BOSTON EDISON

Pilgrim Nuclear Power Staticin Rocky Hill Road Plymouth, Massachusetts 02360

> September 17, 1988 BECo 88-136

RESPONSE TO MRC BULLETIN 85-03, SUPPLEMENT 1

HPCI System Steam Lines Motor Operated Valves

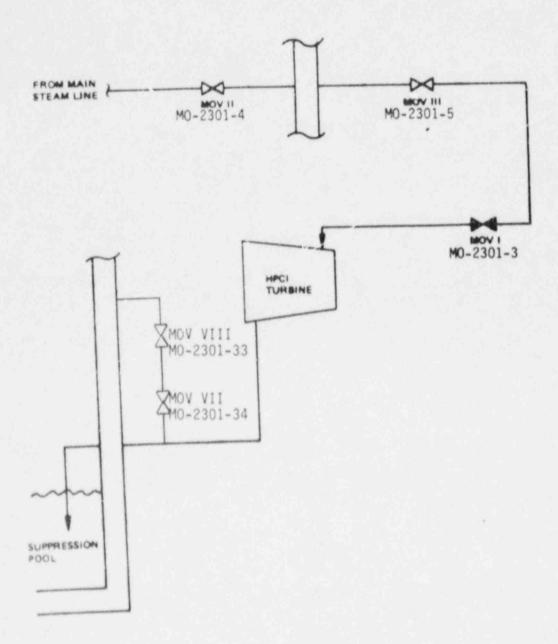
Two new valves were added to the list to reflect their addition to Pilgrim. The new valves are shown on the attached schematic drawing of the HPCI Steam Lines Motor Operated Valves.

- 1) MO-2301-33 Vacuum Breaker Line Isolation Valve
- 2) MO-2301-34 Vacuum Breaker Line Isolation Valve
